ENCLOSURE
Proposed Amdt. to OL/Change to Tech. Specs:
Consisting of revisions to Tech. Spec, with
regards to Control Rod and Power Distribution
Limits.....W/Attachments

February 25, 1976
L-76-69

Re: Turkey Point Units 3 and 4
Docket Nos. 50-250 and 50-251
Proposed Amendment to Facility
Operating Licenses DPR-31 and DPR-41

FIGURE 3.2-1

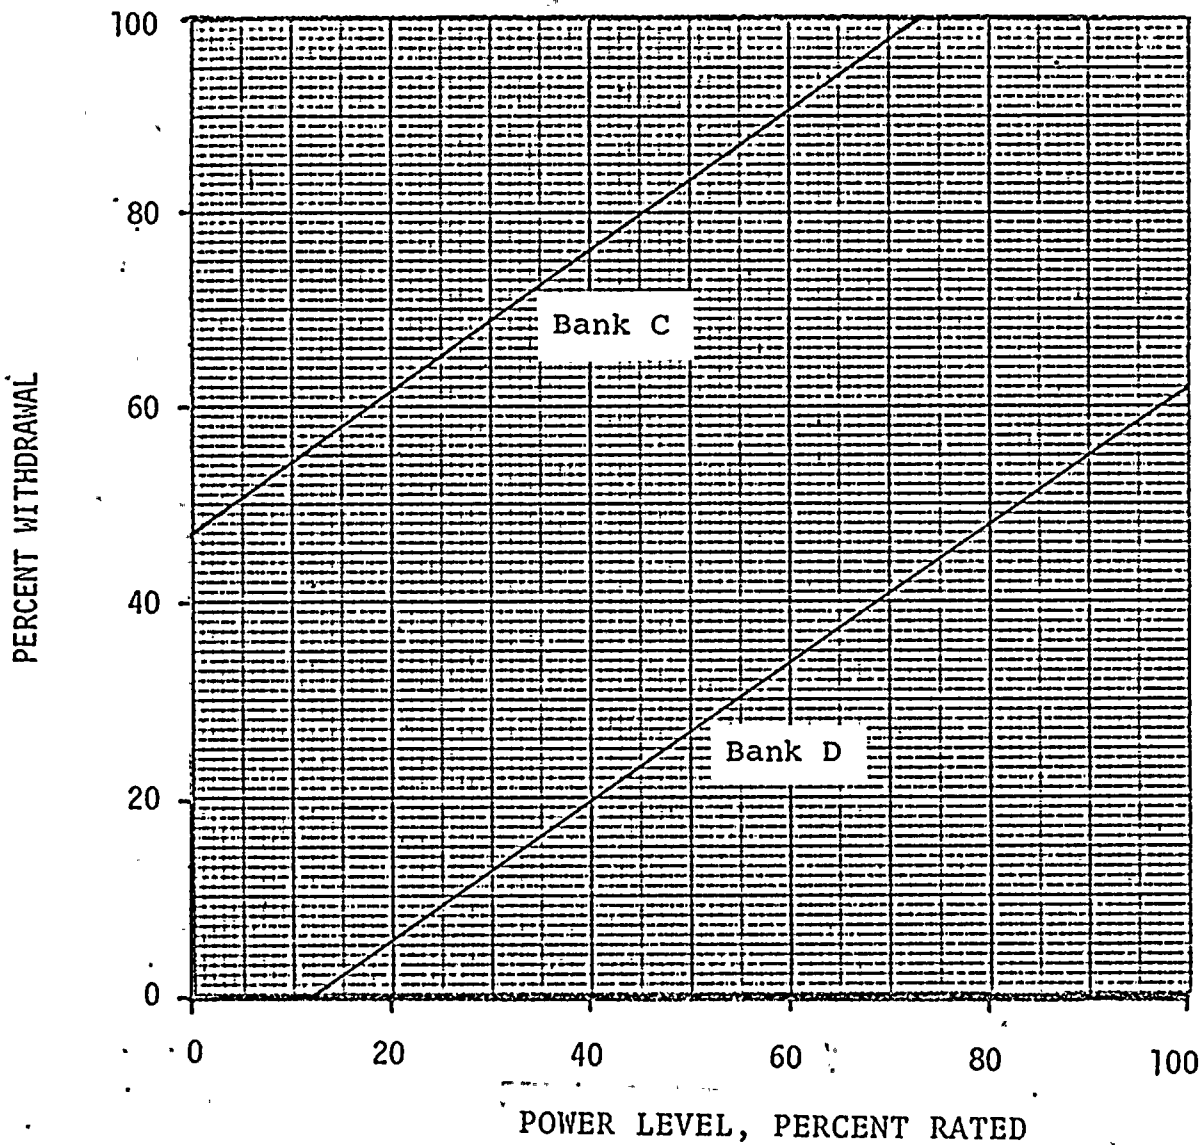
The control group insertion limit graph for Unit 4 three loop operation is revised to be consistent with one insertion

limit which is applicable for the entire cycle. The revised graph is identical to the dashed-line portion of the Cycle 2 graph.

FIGURE 3.2-1(a)

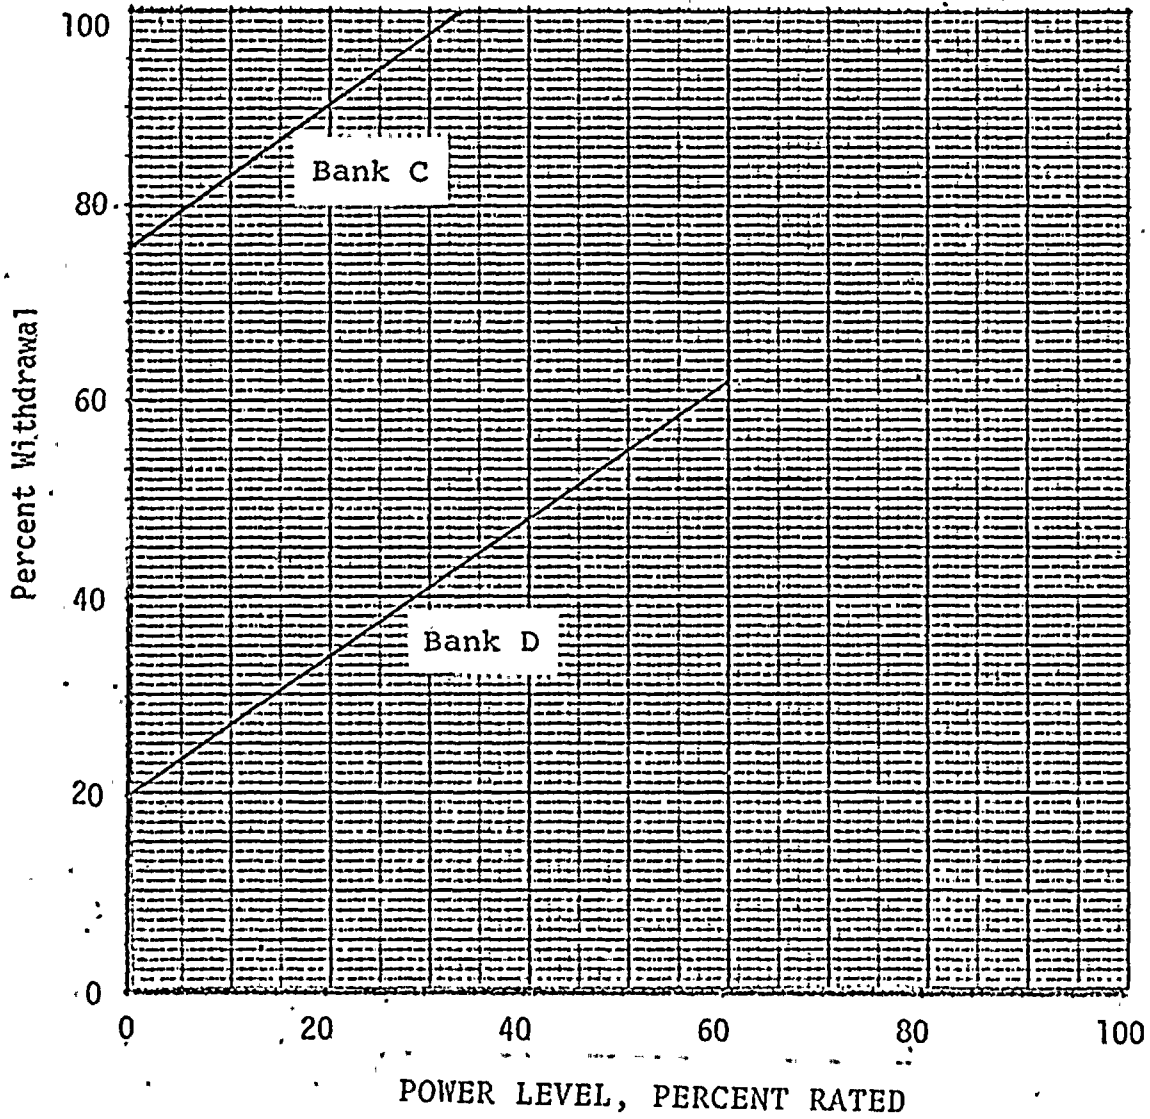
More conservative control group insertion limits are provided for Unit 4 two loop operation.
